**RFB 20-007 Courtland Avenue Extension  
 Peach County Board of Commissioners  
 TPE NO. PCO 044**

**May 22, 2020**

**ADDENDUM NUMBER NO. 3**

DETAIL - SHADOWBOX FENCE

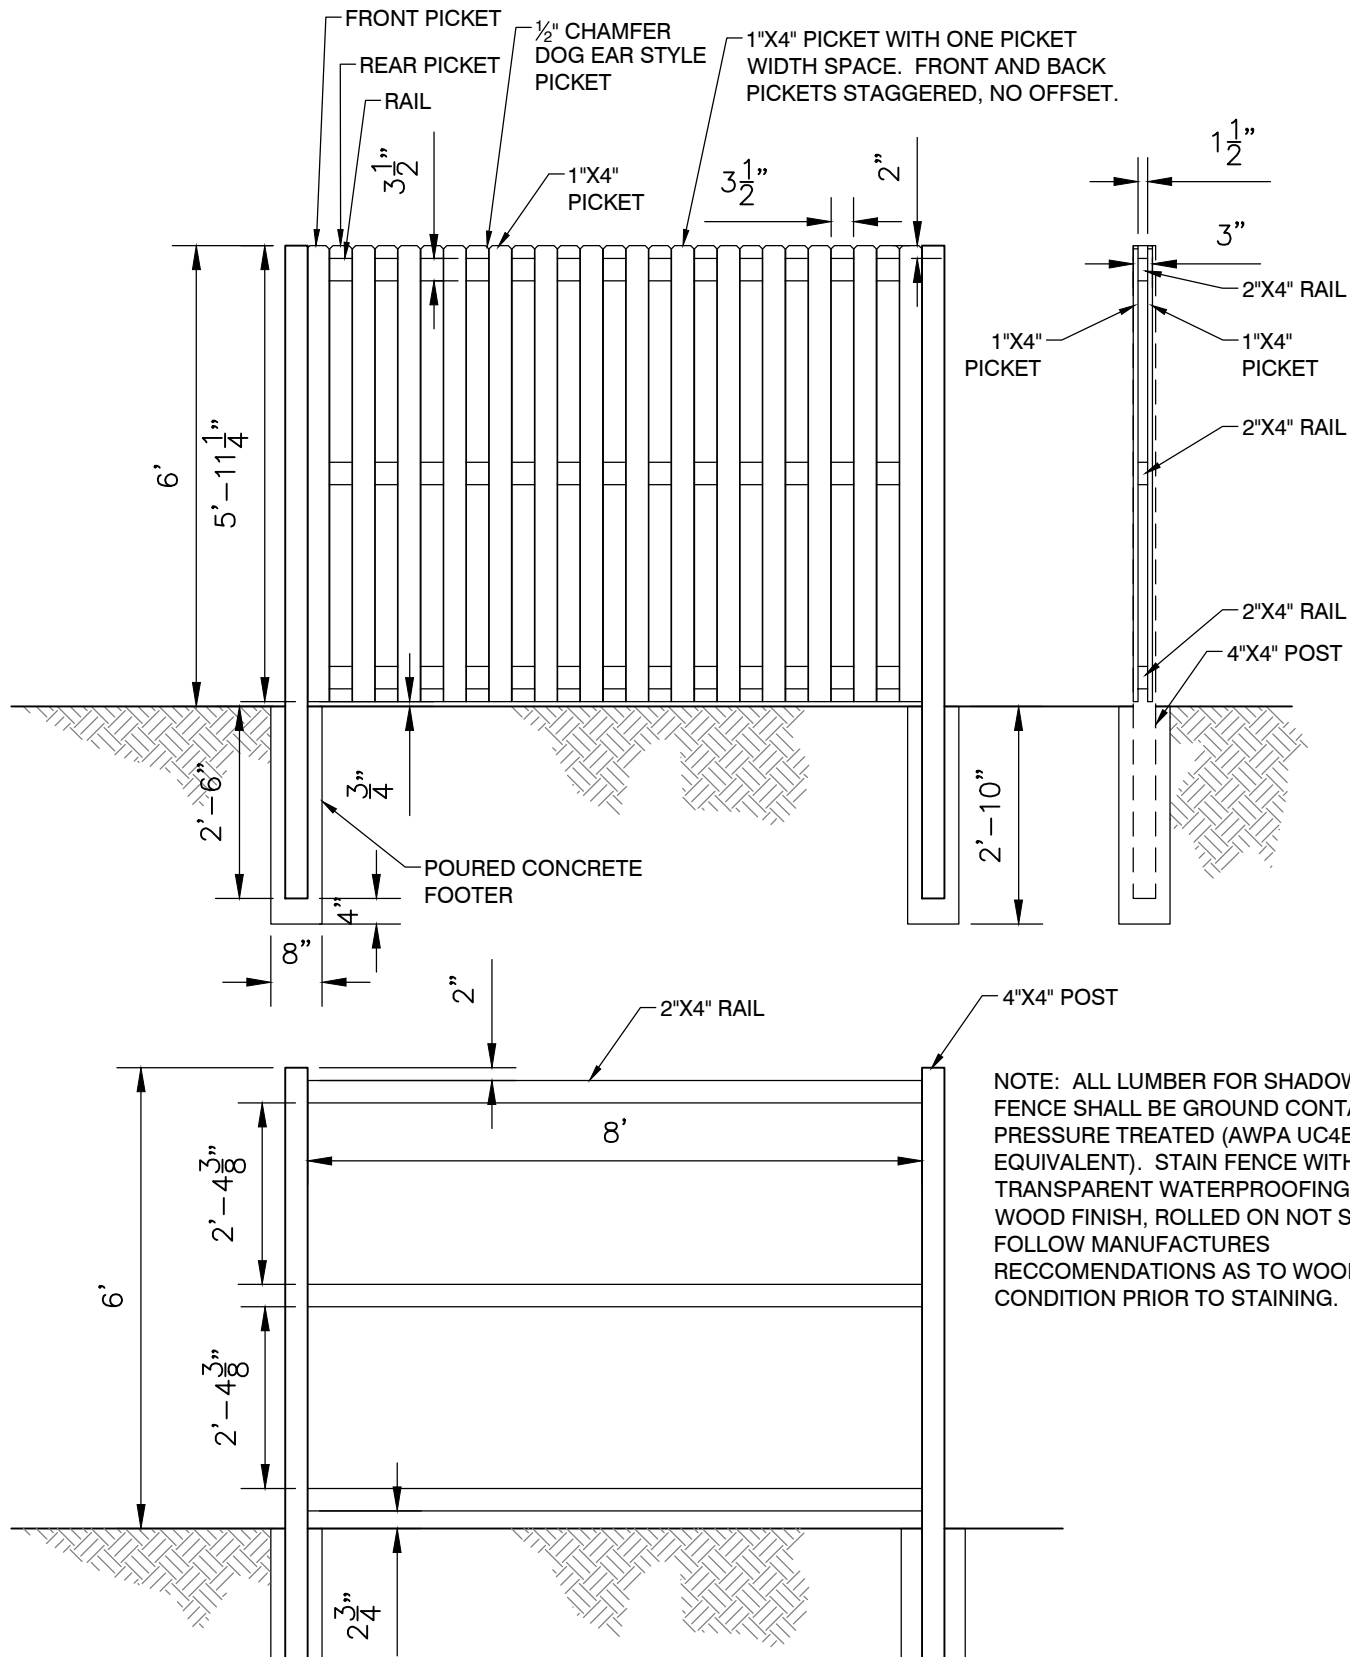
Construction Plans A.) The Shadowbox Fence referenced in the plans near the intersection of Warwick Avenue and Courtland Avenue (plan sheet 2.2, right upper side of plan sheet) shall be constructed according to the Detail- Shadowbox Fence provided in this addendum (Attached).
